Grid Code Code Administration Consultation	At what stage is this document in the process?												
<h1>GC0114:</h1> <h2>Mod Title: 'System Operation Guidelines Prequalification Processes'</h2>

This document is the Draft Final Grid Code Modification Report document that contains the discussion of the Workgroup which formed in June 2018 to develop and assess the proposal, the responses to the Workgroup Consultation which closed on 27 September 2018, the voting of the Workgroup held 05 December 2018. The Panel reviewed the Workgroup Report at their Grid Code Review Panel meeting on 19 December 2018 and agreed that the Workgroup had met its Terms of Reference and that the Workgroup could be discharged. This document also contains the responses received from the Code Administrator Consultation which closed on 28 January 2019.

GC0114 aims to clarify that the EU System Operation Guideline (SOGL) requires NGESO to develop prequalification processes for Frequency Containment (FCR), Restoration (FRR) and Replacement Reserves (RR). In line with stakeholder feedback NGESO proposes to develop these new processes under the established governance of the Grid Code.

Figure 10 – Comparison of responses to a -0.5Hz step and ramp test

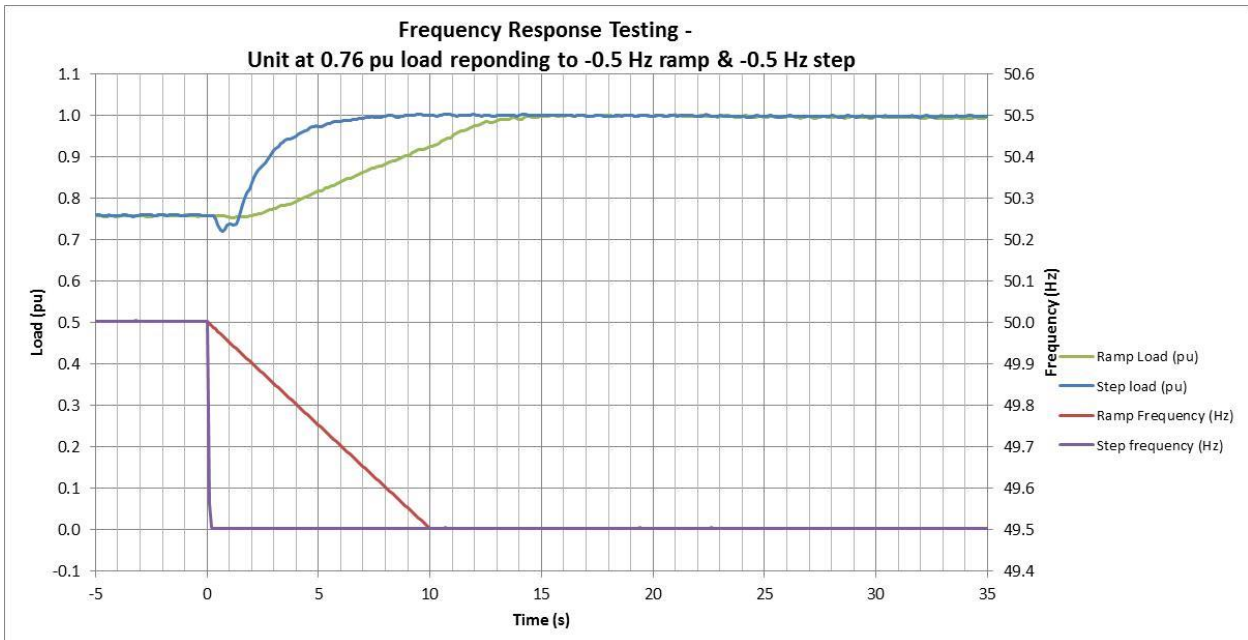
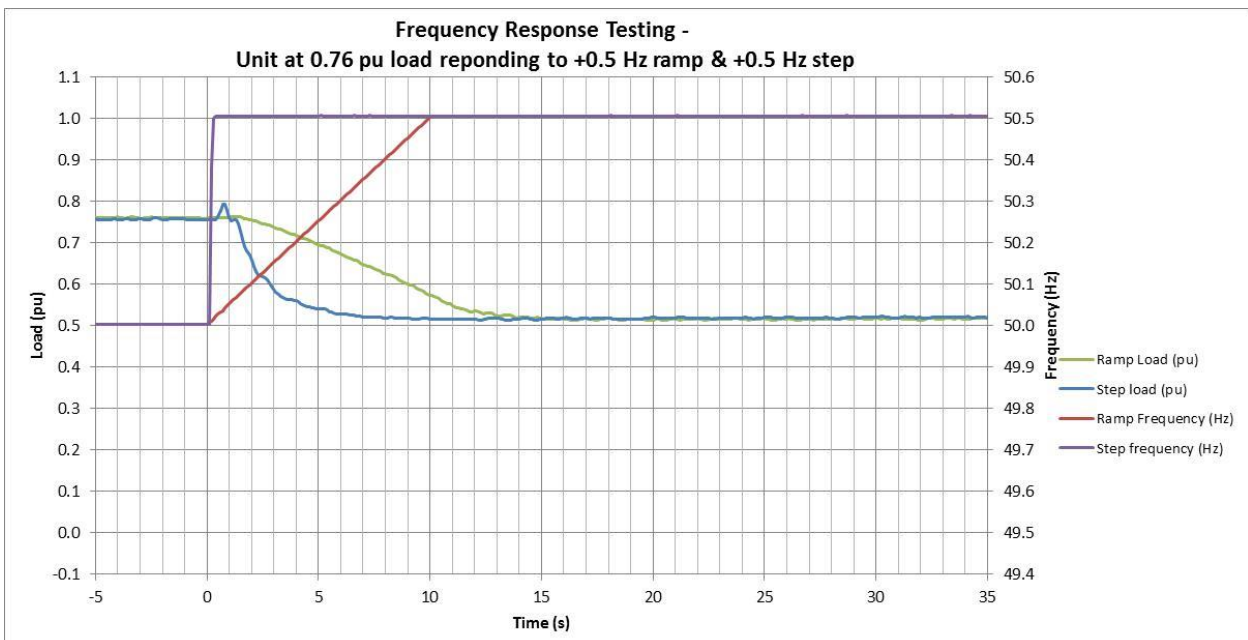
In order to demonstrate of the different responses of the following figure 10 shows the same generator on the same day being tested with a 0.5Hz frequency decrease over a 10 second ramp test 13 and a 0.5Hz step frequency decrease compliance test H. Similarly in figure 11 the same generator on the same day being tested with a 0.5Hz frequency increase over a 10 second ramp test 14 and a 0.5Hz step frequency increase compliance test I.

Reviewing the primary response in figure 10 based on a 10s ramp the response is 0.186 pu, whilst if the result is based on a step test the response is 0.241pu, hence a ramp test only gives 70% the response of a step response. Similarly the high response in figure 11 based on a 10s ramp the response is 0.191pu, whilst if the result is based on a step test the
